**September 2006 Errata to
Final Environmental Impact Report
September Ranch Subdivision Project
Monterey County, California**

SEPTEMBER 2006 ERRATA TO FINAL EIR

September Ranch Subdivision Project
Re-circulated portion of Draft Revised Environmental Impact Report
SCH 1995083033, Monterey County

September Ranch
Monterey Pine Forest Habitat
Cumulative Impact Assessment

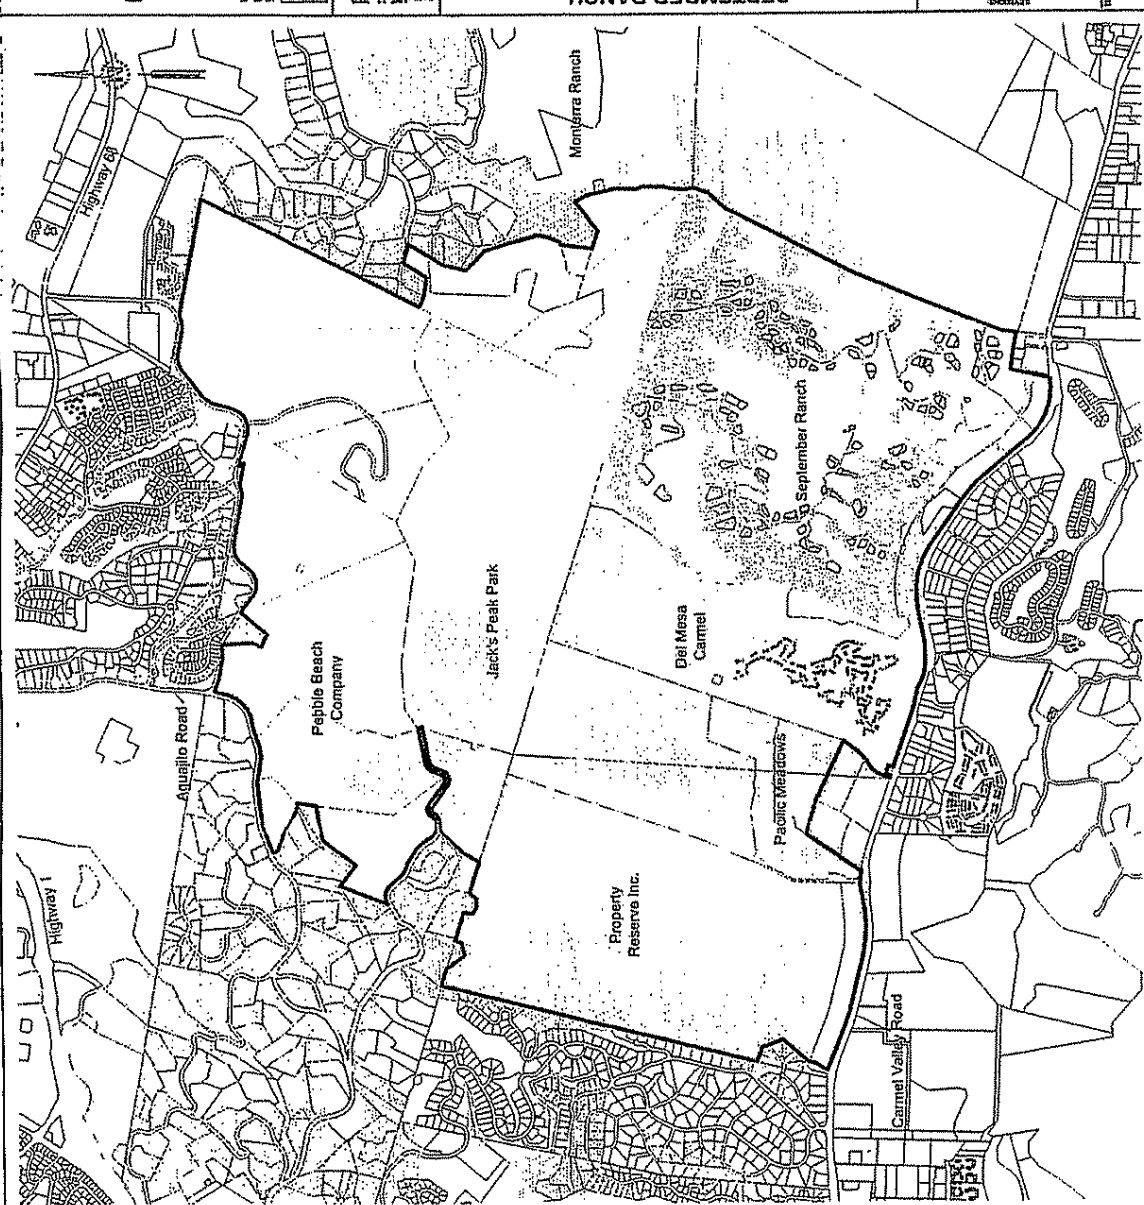
A cumulative impact assessment study area was defined based on the occurrence of large remaining blocks of intact Monterey pine forest contiguous with the ridges adjacent to Jack's Peak Regional Park and the project site (see Figure). Monterey pine forest habitat in this area occurs primarily on inland Monterey shales with coast live oaks often forming a subcanopy and typical understory associates including grasses and mixed shrubs such as poison oak, bush monkeyflower, California blackberry, coyote brush and California coffeeberry. Notable differences between this habitat type and Monterey pine forest on different soils at lower elevations on the Monterey Peninsula have been identified (Jones and Stokes Associates, 1994). Therefore, it is appropriate to consider cumulative impacts to this habitat type on a sub-regional basis.

Seven contiguous and relatively large ownerships covering an area of approximately 3,758 acres define the study area (see Table and Figure). While other, mostly smaller land holdings with this type of Monterey pine forest habitat occur in the vicinity outside of this study area, those parcels are primarily developed as single family residential parcels; in most cases, their ultimate disposition relative to open space dedication and land use restrictions has long been established and does not materially affect this cumulative impact assessment.

On the seven ownerships, Monterey pine forest occurs on approximately 3042.5 acres or on over 80% of the land area within the study area. Previously dedicated or otherwise set aside and undeveloped open space primarily supporting Monterey pine forest occurs on three of the seven ownerships (Del Mesa Carmel, Pacific Meadows and Monterra Ranch) adjoining Jack's Peak Regional Park and totaling about 460.5 acres. A minimum of 266 acres of the 796.3 forested acres on Pebble Beach Company holdings at Aguajito have been committed to open space as part of the recent approval of the Del Monte Forest Preservation and Development Plan. When added to the 826 acres of Monterey pine forest within public open space at Jack's Peak Regional Park, the existing and proposed dedicated acreage totals about 1,552.5 acres or over 50% of the Monterey pine forest habitat in the study area.

Development of roads, infrastructure and houses on September Ranch would directly affect about 34.9 acres of the existing 426 acres of Monterey pine/coast live oak forest on the property. The remainder of the forested land (over 390 acres) would remain relatively undisturbed as either common or private open space. A significant portion of the forested land on September Ranch contiguous to Jack's Peak would be dedicated through conservation easement or other appropriate means to increase the habitat preserve "footprint" adjacent to the regional park.

There are no reasonably foreseeable probable future projects within this study area. There are two parcels in the study area contain Monterey pine forest and have some development potential: the remaining 530.3 forested acres on Pebble Beach Company holdings at Aguajito & the 533.3 forested acres on lands of Property Reserve, Inc. However, no applications to develop these parcels have been submitted and there are no proposals for development of these properties. Slope constraints substantially limit the development potential of both sites. In addition, the PRI parcel is under a Williamson Act contract which limits its use to agriculture for the duration of the contract period.

Comment noted. Although not specifically referenced in the REIR, this information was independently reviewed by the project consultants in reaching impact conclusions.
